**INTERNATIONAL CODE COUNCIL
2013 CODE DEVELOPMENT CYCLE**

**2013 REPORT OF THE COMMITTEE ACTION
ON THE 2012 EDITIONS OF THE**

**HELD IN DALLAS, TEXAS
APRIL 21ST – APRIL 30TH, 2013**

FIGURE R602.7.2
TYPICAL WOOD STRUCTURAL PANEL BOX HEADER CONSTRUCTION

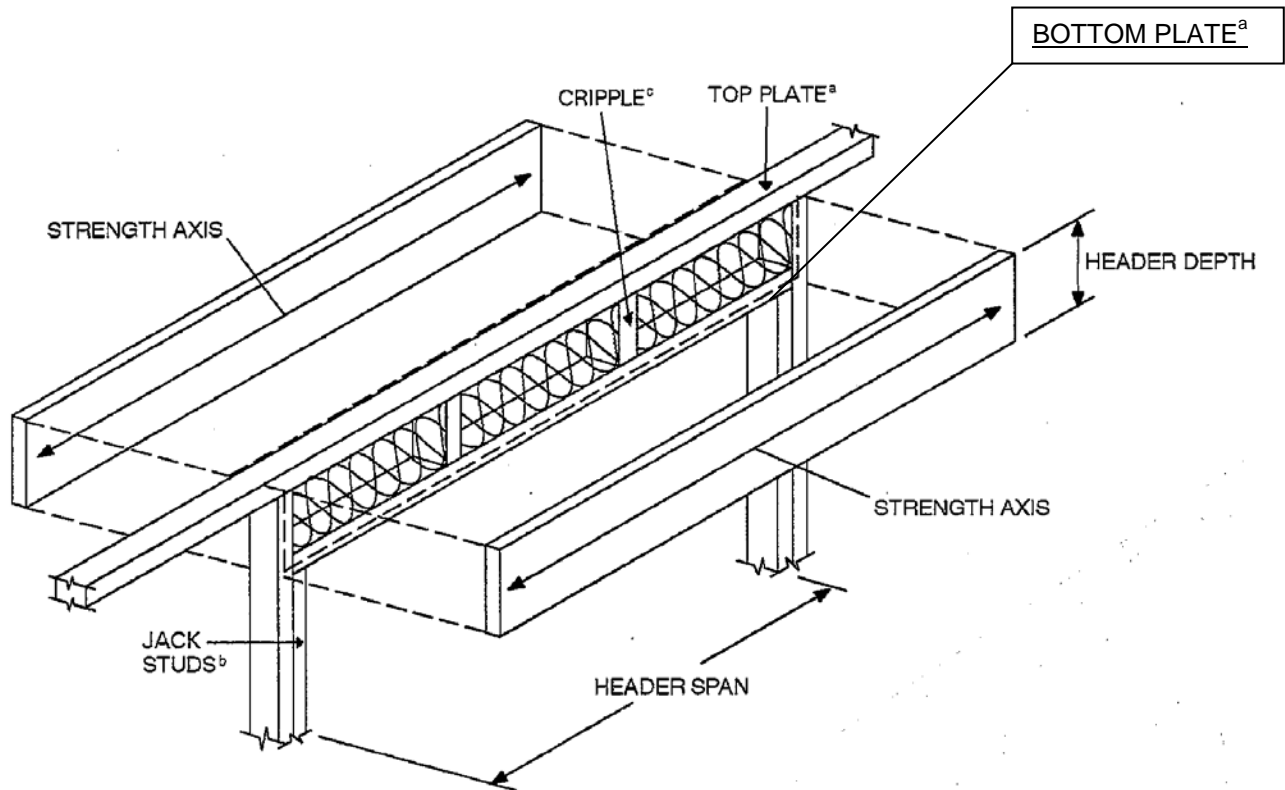
RB285-13

The following is errata that was not posted to the ICC website (The line from "Bottom Plate" has been shifted):

- a. The top and bottom plates shall be continuous ever-at header location.
